# University of Kentucky<sup>®</sup>

CCK-2564.0-9-24

Construct Health Education Building

ADDENDUM #3

**FRAMING PLAN - FIRST FLOOR - AREA A**  
S-111A  
1/8" = 1'-0"

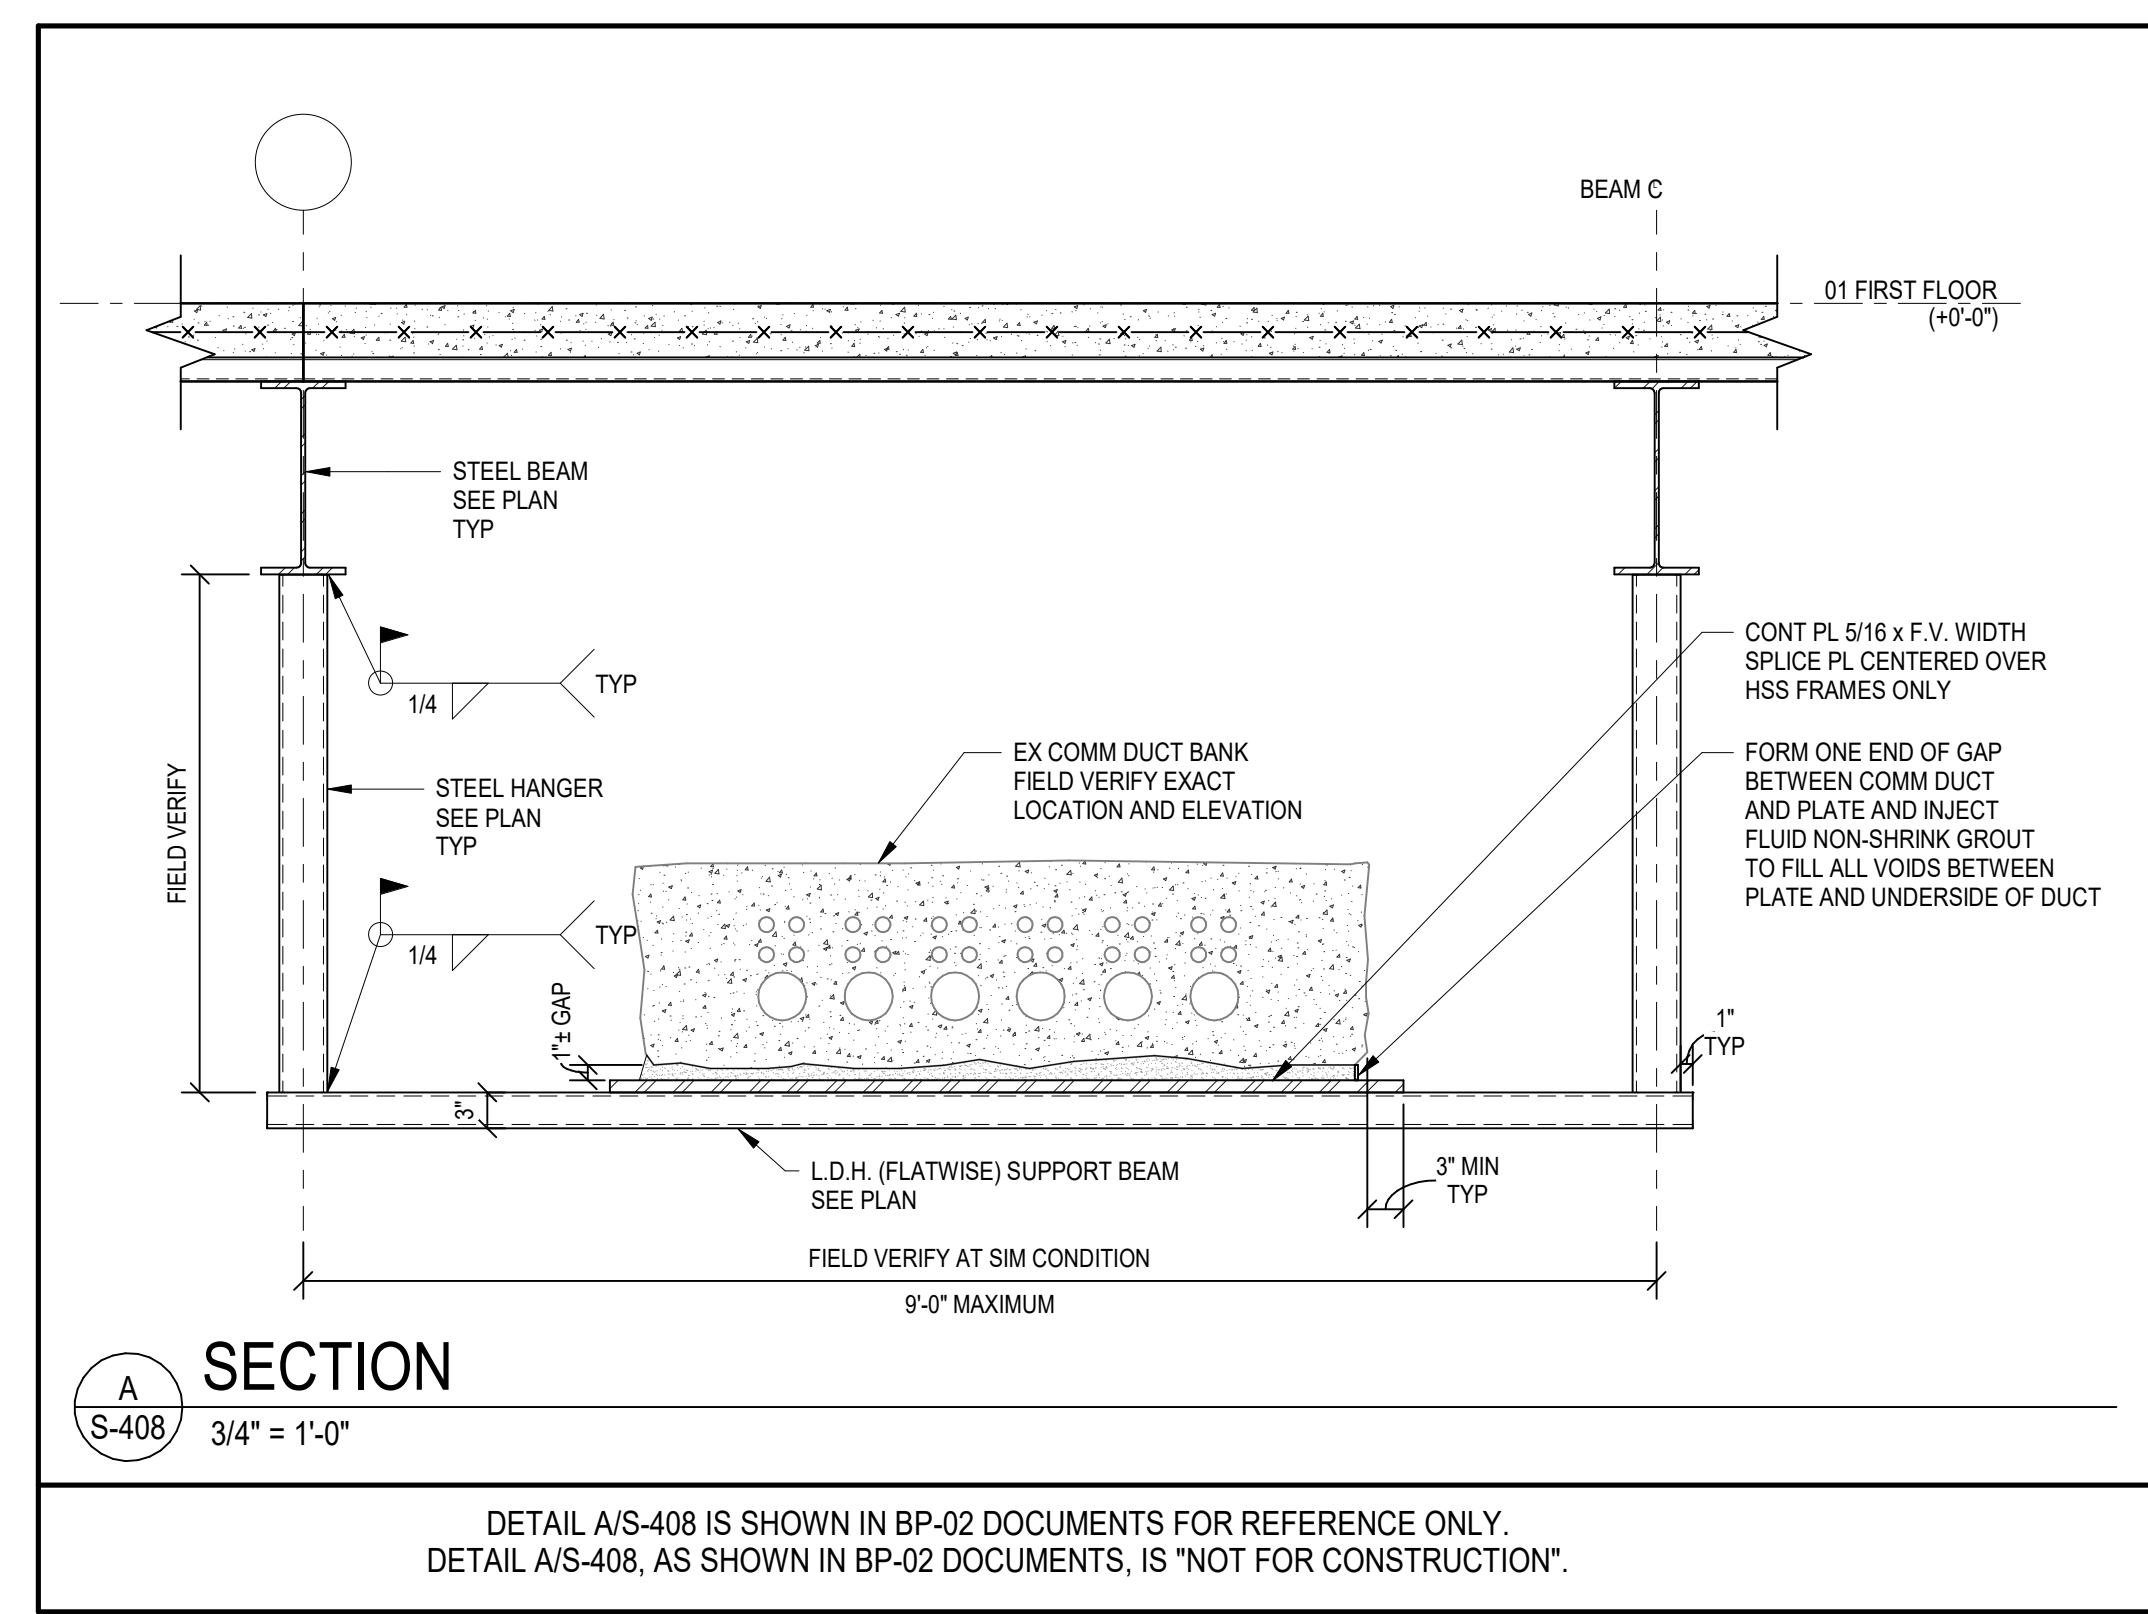
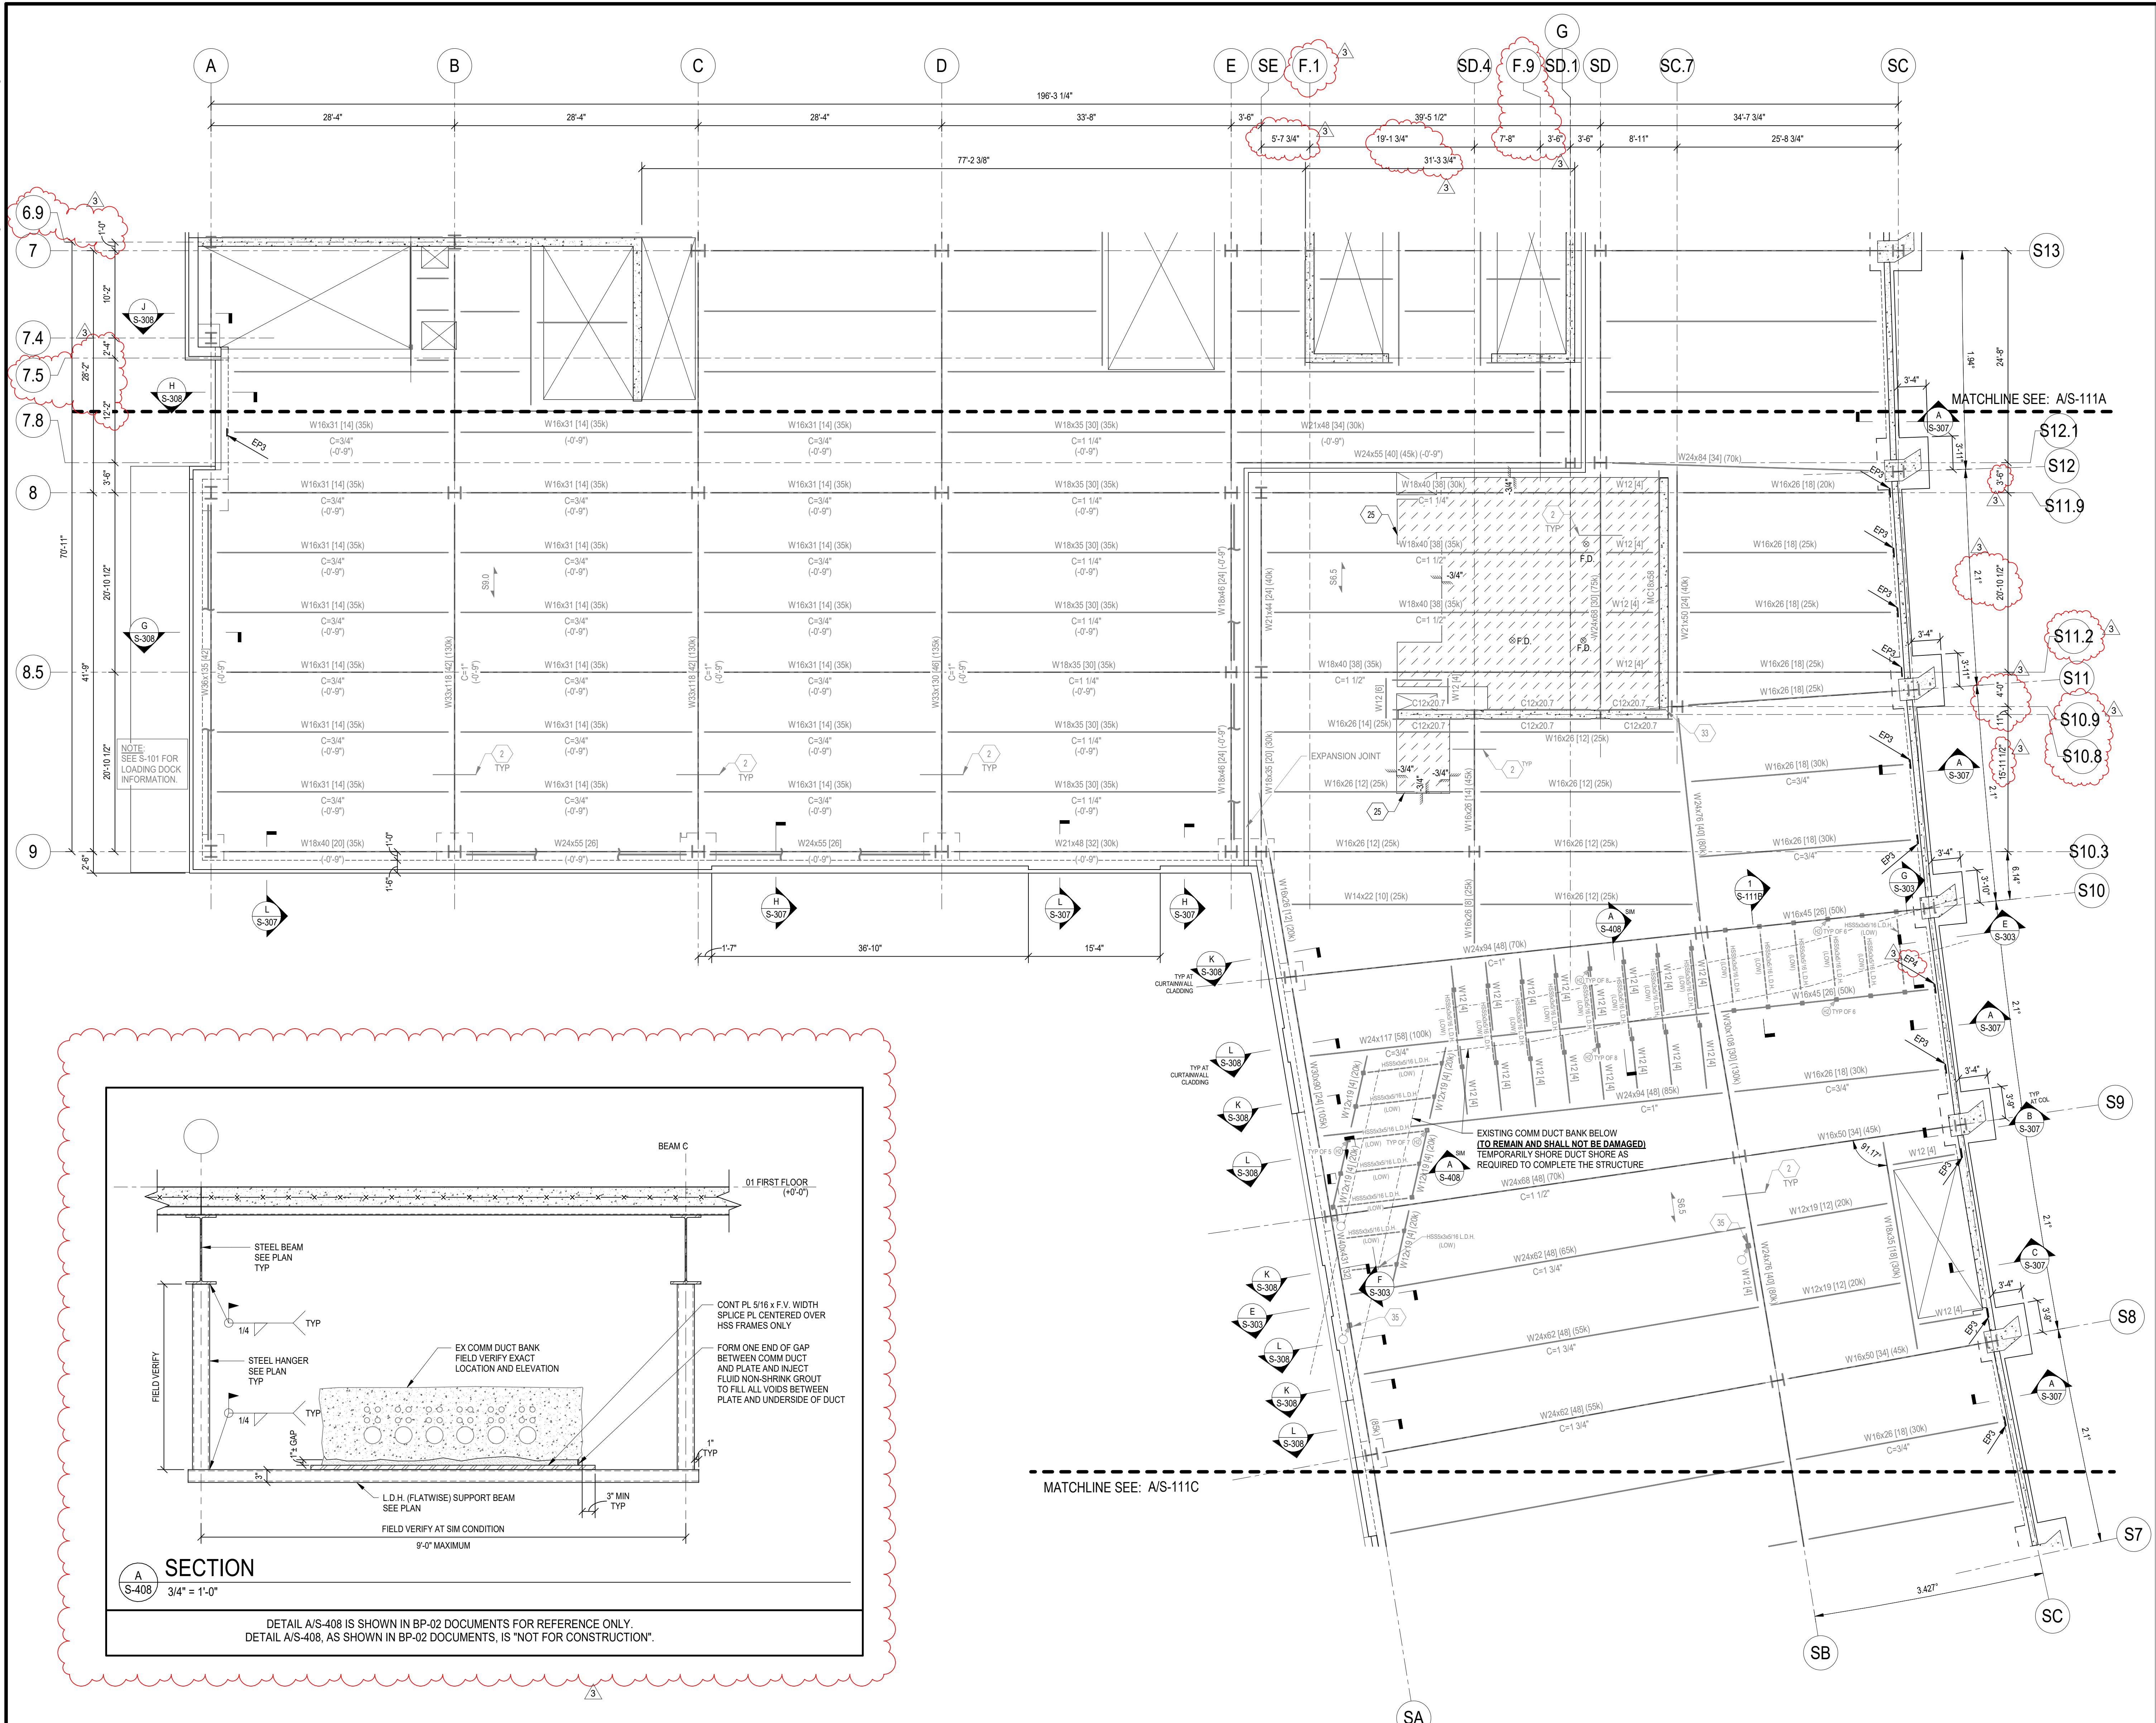
Refer to attached sheet S-111A. Framing Tag Notes moved to sheet S-002. Updated gridlines and dimensions and updated embed plates.

**S-111B**

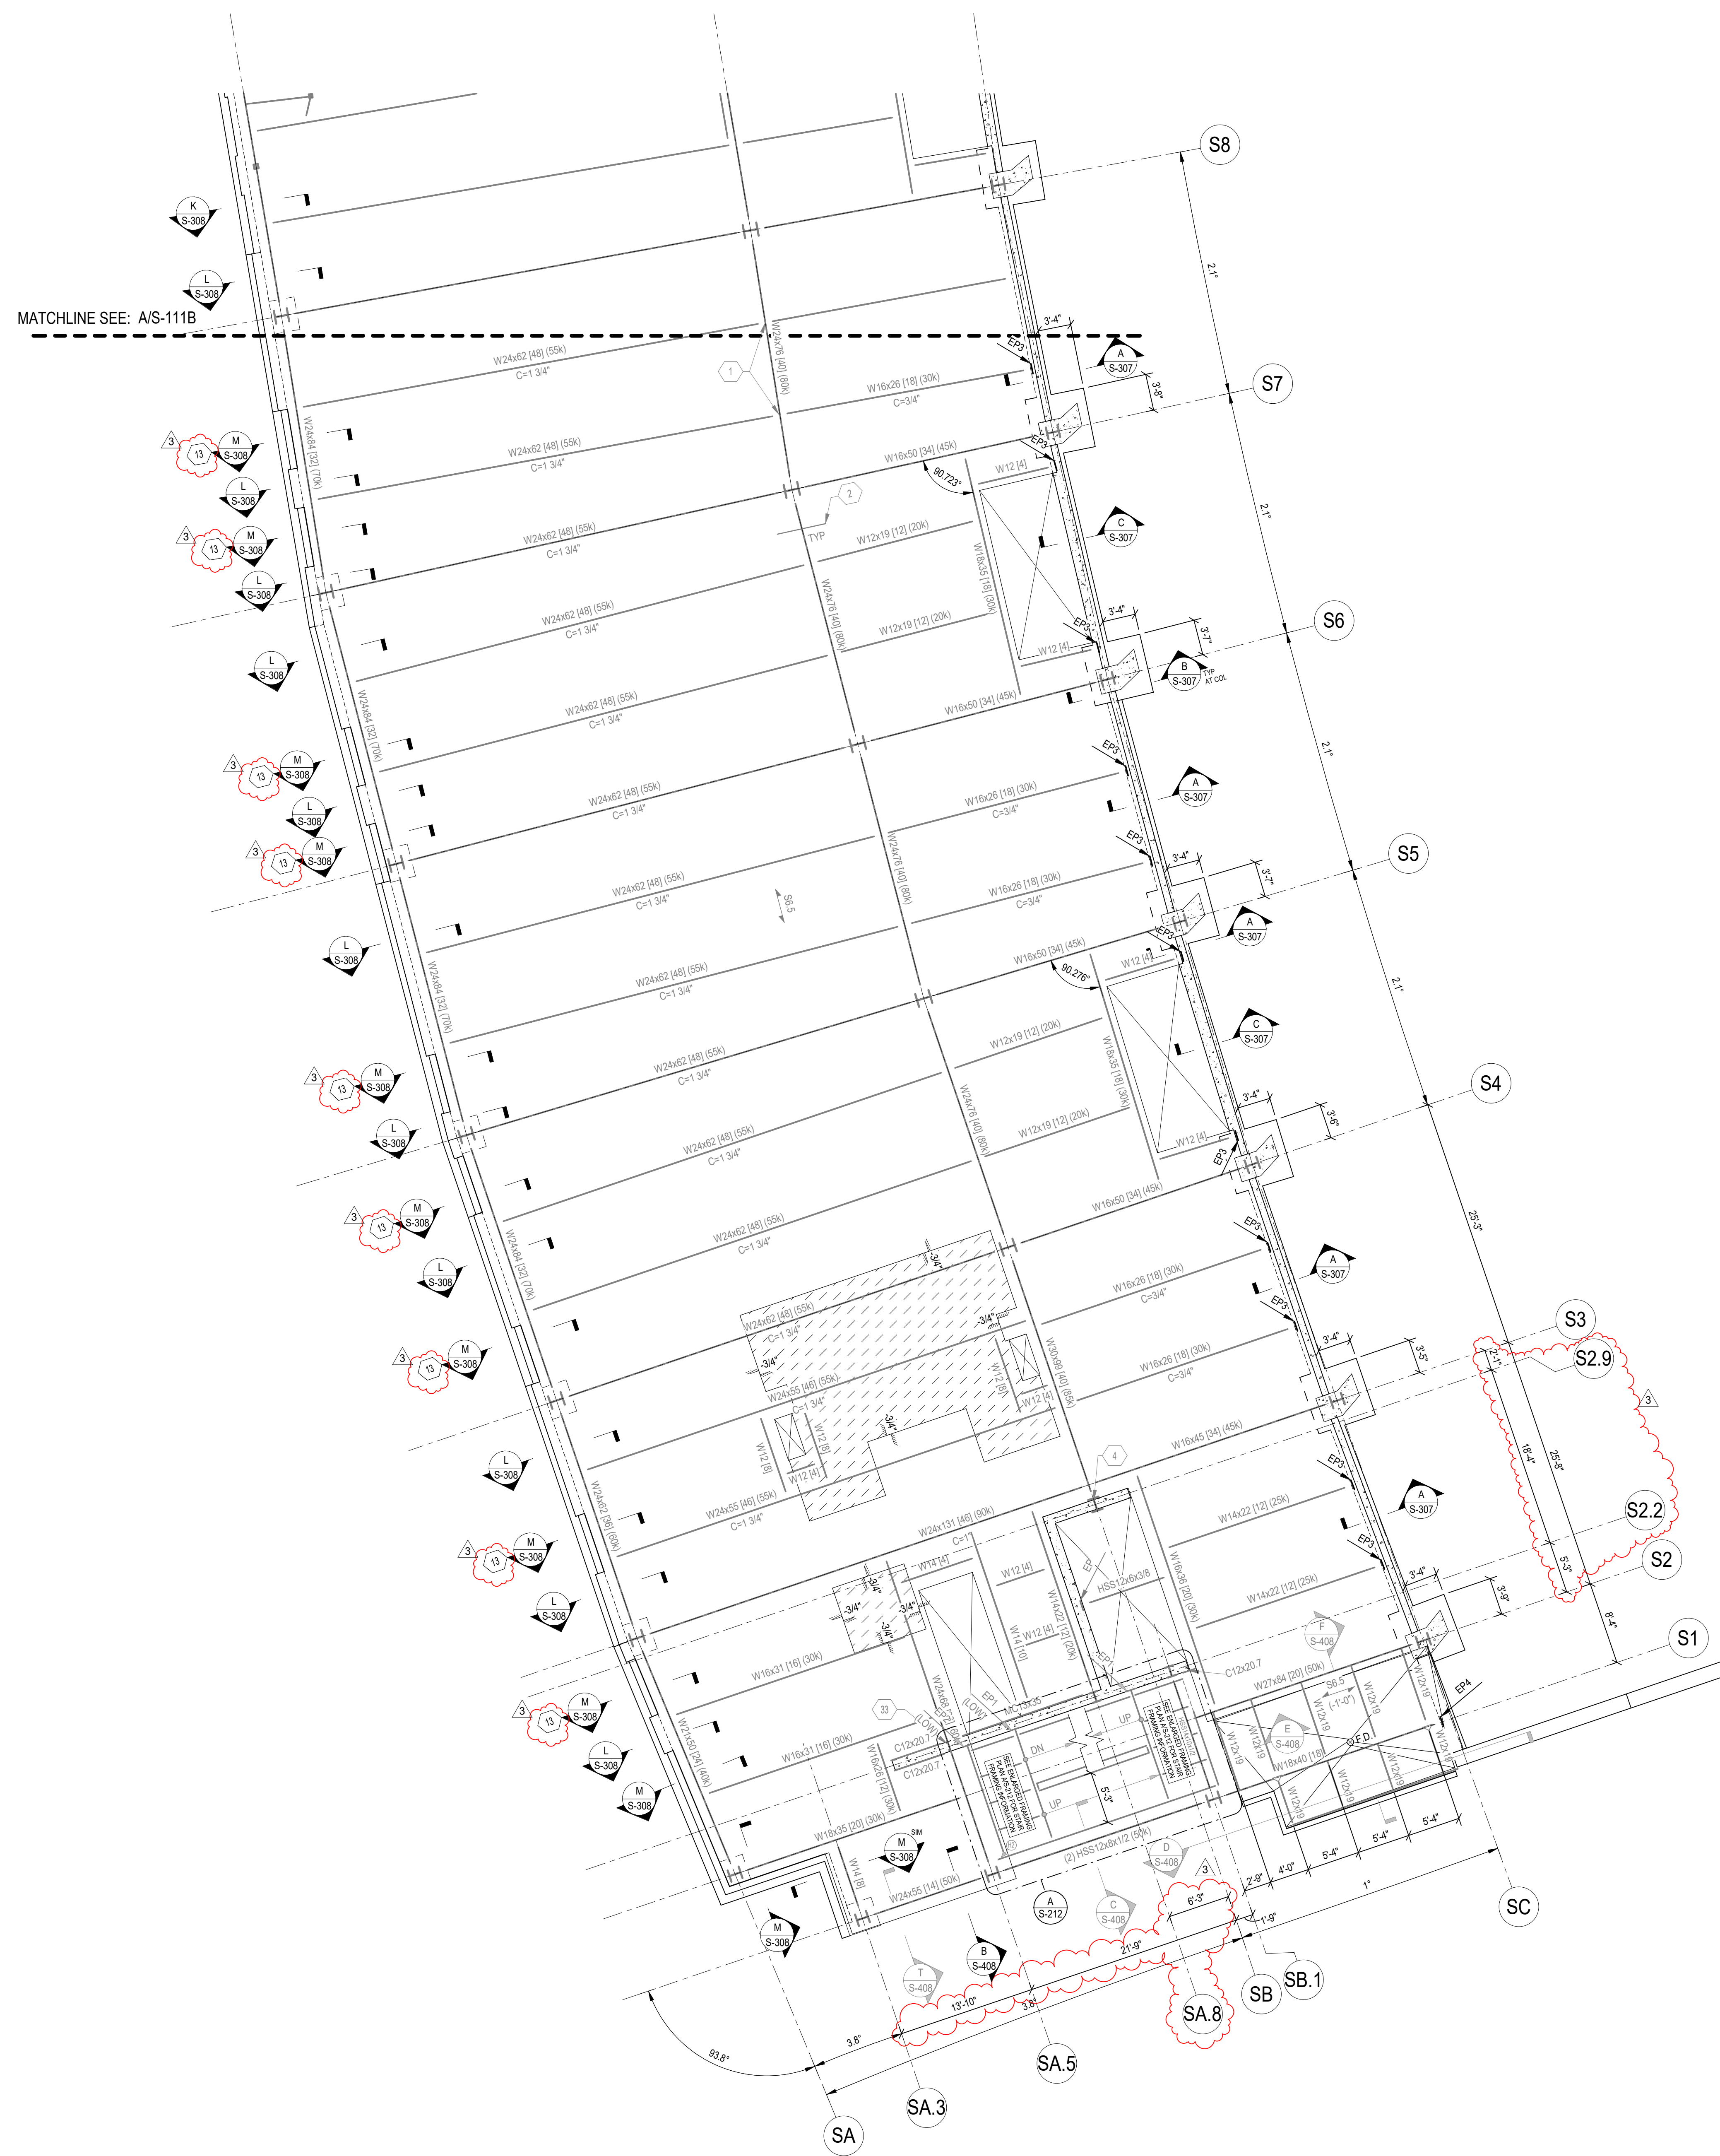
Refer to attached sheet S-111B. Framing Tag Notes moved to sheet S-002. Updated gridlines and dimensions. Added section at existing comm duct bank permanent support framing detail (for reference only).
